GOVERNMENT OF INDIA
MINISTRY OF ENVIRONMENT & FORESTS
Central Zoo Authority

F. No. 19-58/93-CZA(190)(Vol.III)(M) / 4221

Sub:- Design for the construction of various enclosures at Manipur Zoological Garden, Imphal, Manipur.

The designs for the construction various enclosures at Manipur Zoological Garden, Imphal, Manipur were placed before the 46th Meeting of the Expert Group on Zoo Designing of the Central Zoo Authority held on 3rd January, 2014. After detailed deliberation, the following observations were made:-

Design for the proposed construction of New Aviary Enclosure for Manipur Zoological Garden, Irosemba Imphal.

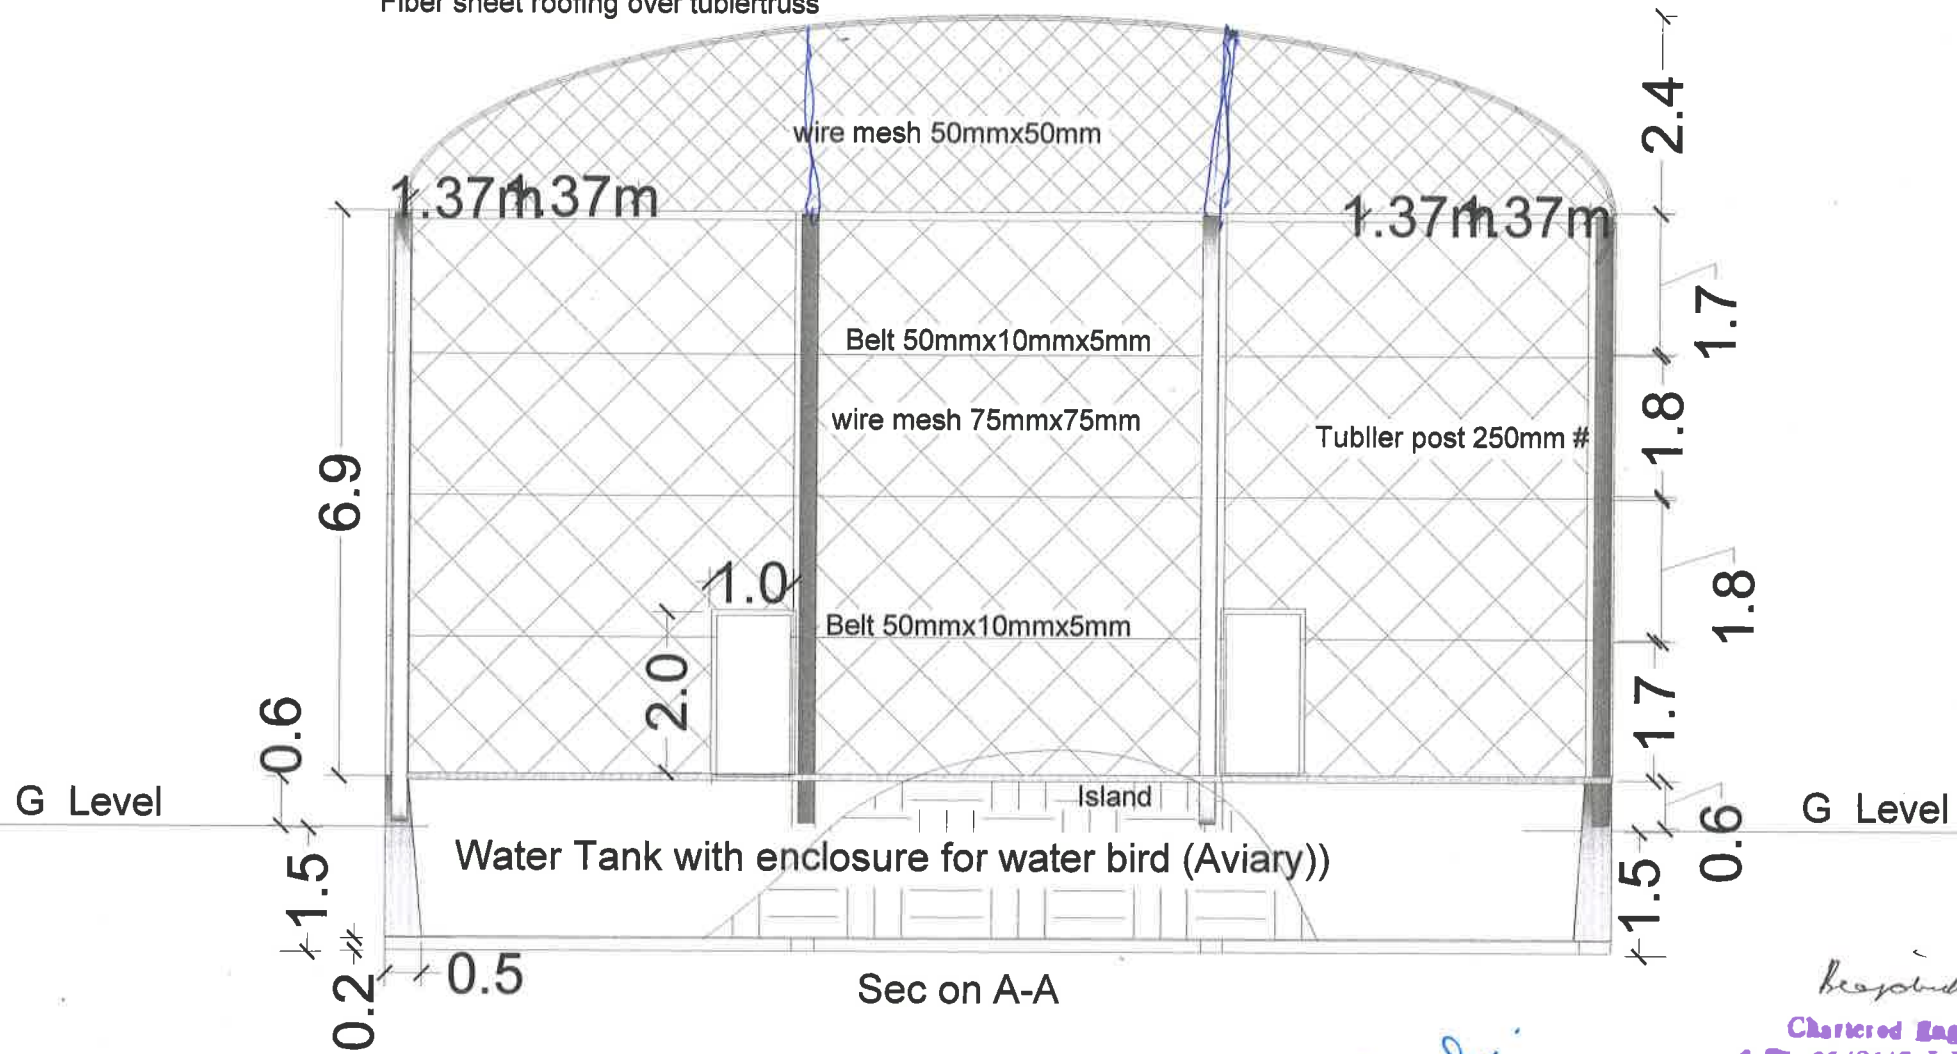
Design for aviary is approved with following amendments :

- Top of the aviary should be covered with fiber mesh instead of fiber sheet in the previous instructions issued from this office, word "sheet" was erroneously typed.

- b) Instead of using the bird Belt for tying up chain link with vertical posts, the iron strip should be used known as M.S. flat. Therefore, use this nomenclature in your corrected designs.

Corrected copy may please be sent to this office for authentication & record.
